COMMUNITY DEVELOPMENT
 DEPARTMENT
 Approved
 7/26/18
 Zoning Certificate #:
 4365

| 29 COLLEGE ST. HUDSON O. | | |

| | | DRAWING NUMBER 2 |

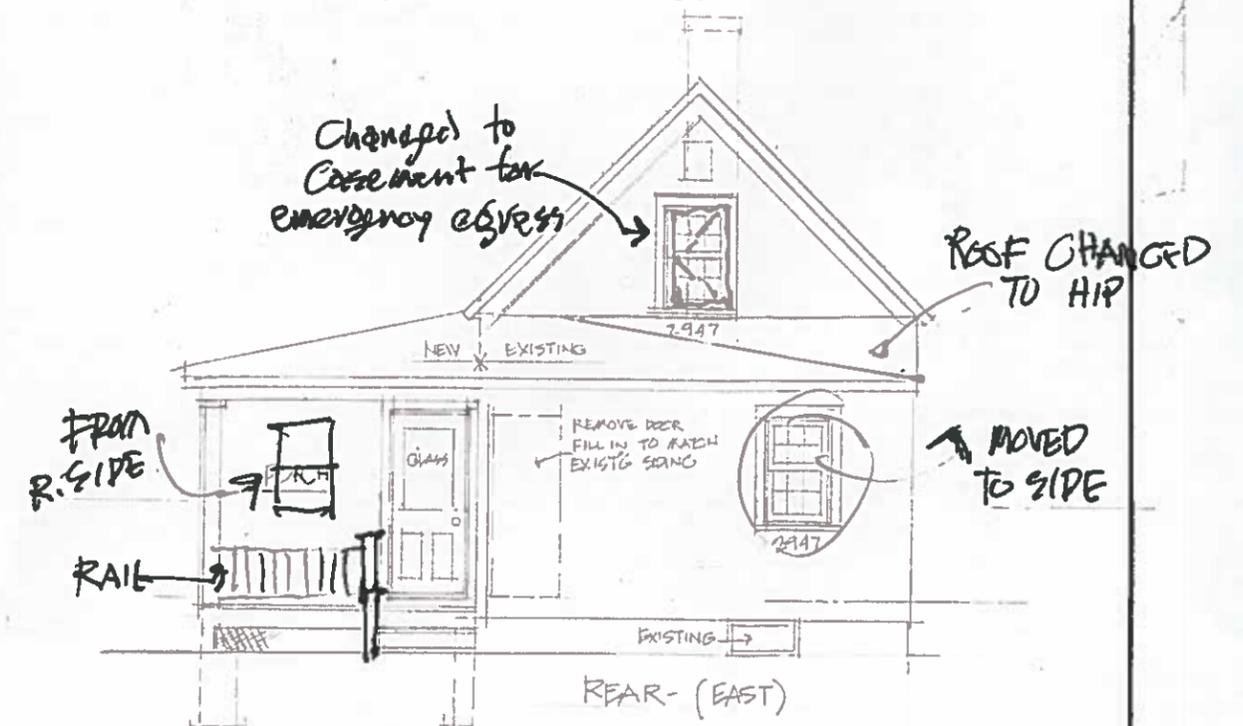
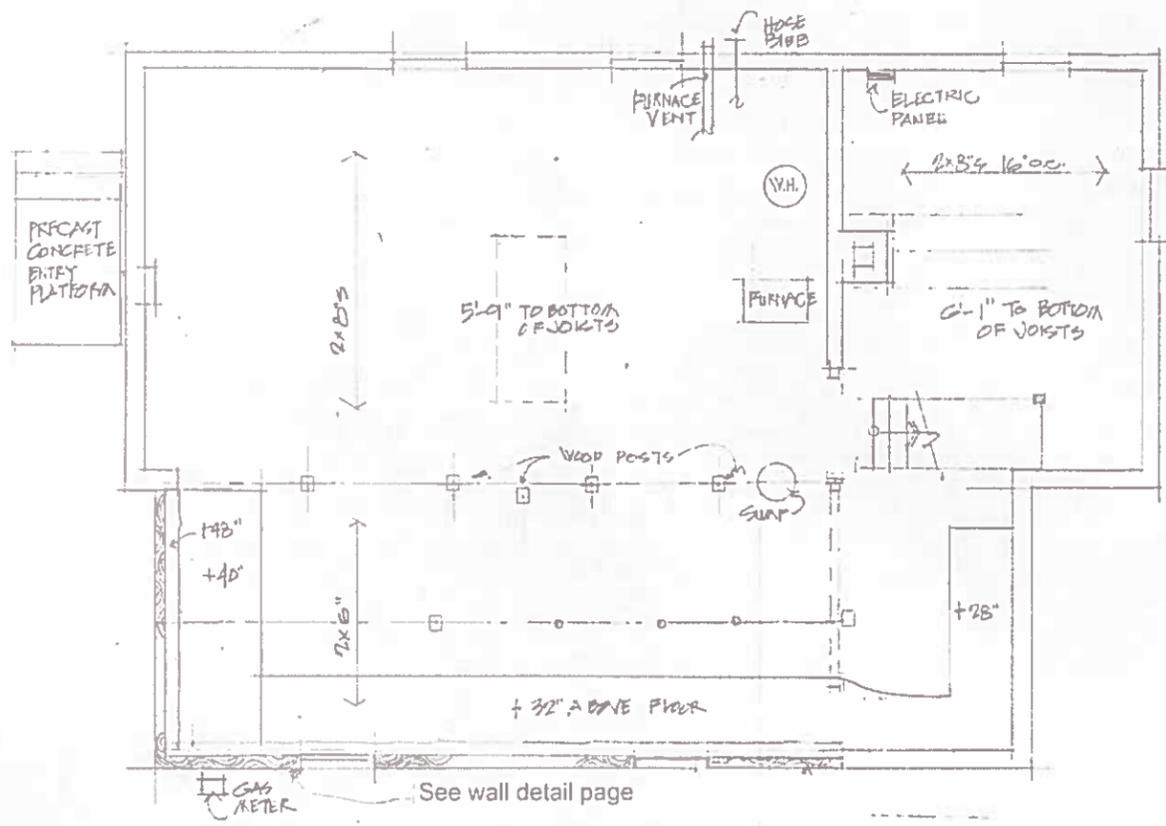
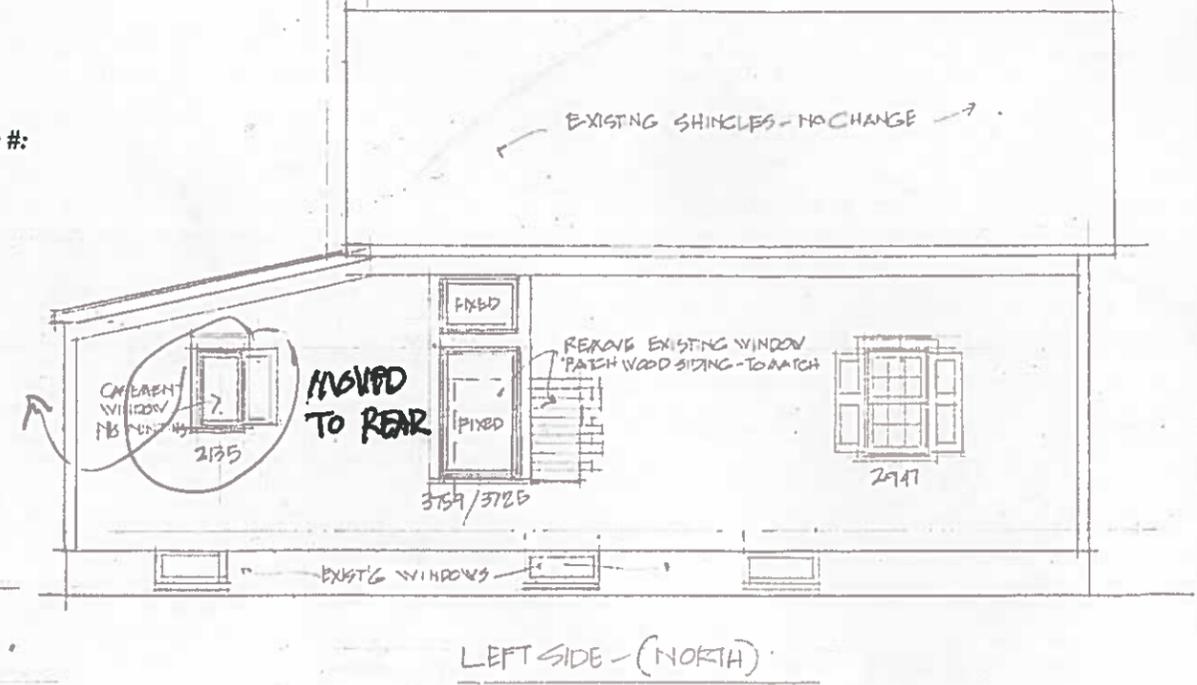
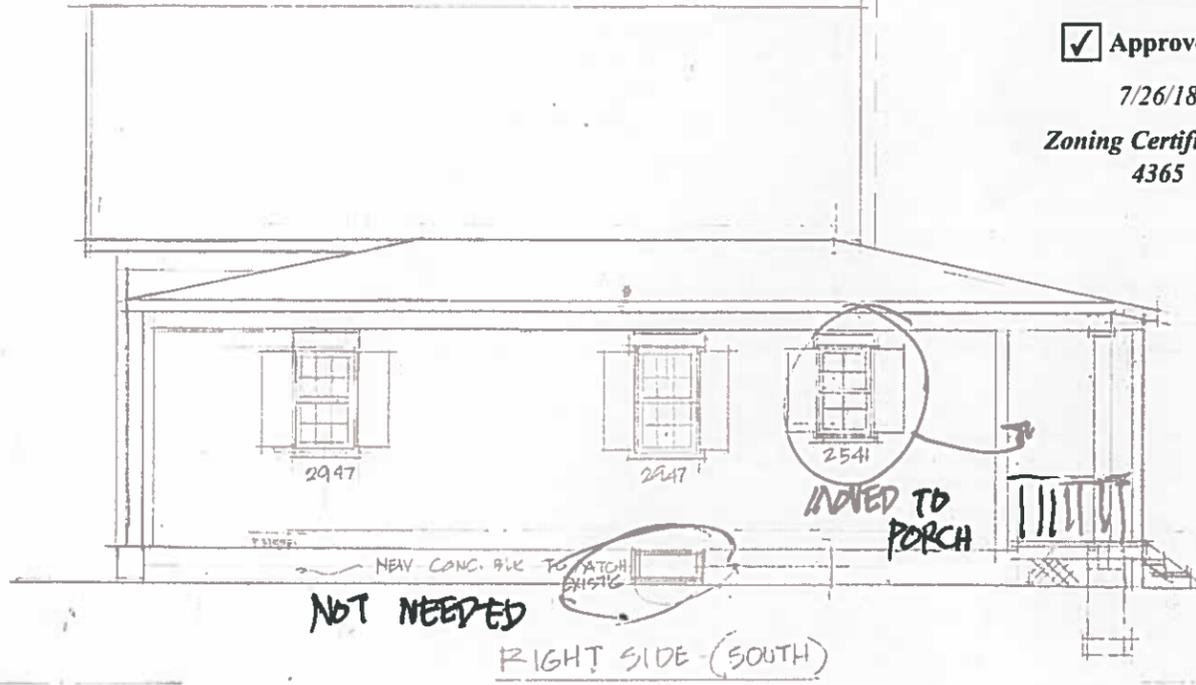
The rear-view windows – Second floor window was changed to a crank out style as it can be used for emergency exit from second floor to roof.
The chimney was able to be taken down to basement and this allowed the kitchen sink to be moved to face the rear yard and the casement window from driveway was traded for the double hung window in the rear. The casement window then in the first-floor rear was centered below the second-floor window.
No muntin bars on the rear elevation allows for clear view of the backyard. (Non-public face)

NO MUNTIN BARS
 ELEVATION FOR
 BETTER VIEW
 OF REAR YARD
 THESE WINDOWS ARE
 NOT ON PUBLIC FACE

| | | 1 |

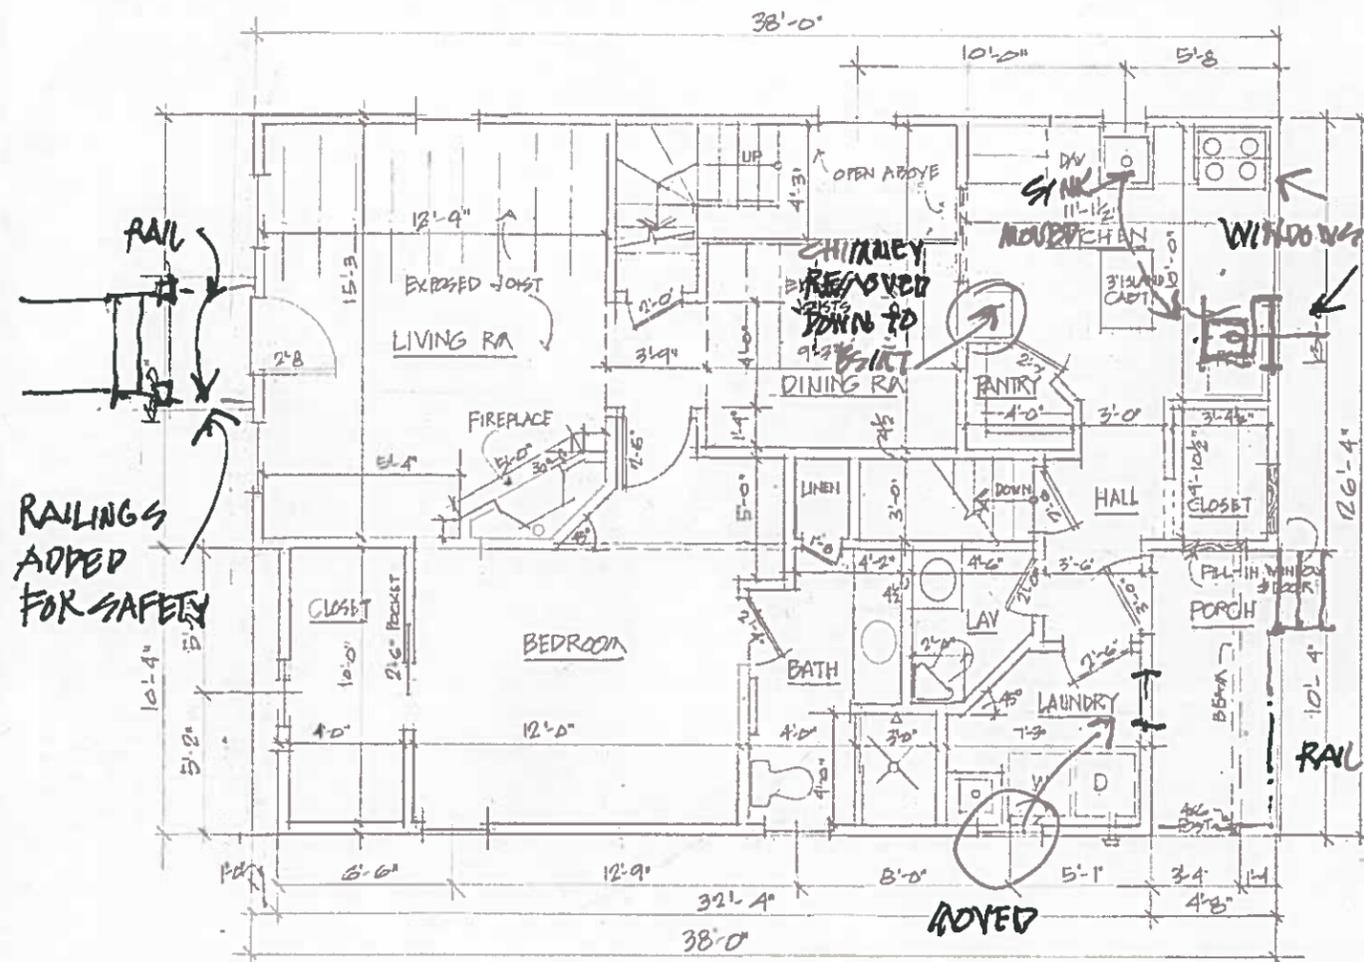
WINDOW EXCHANGED
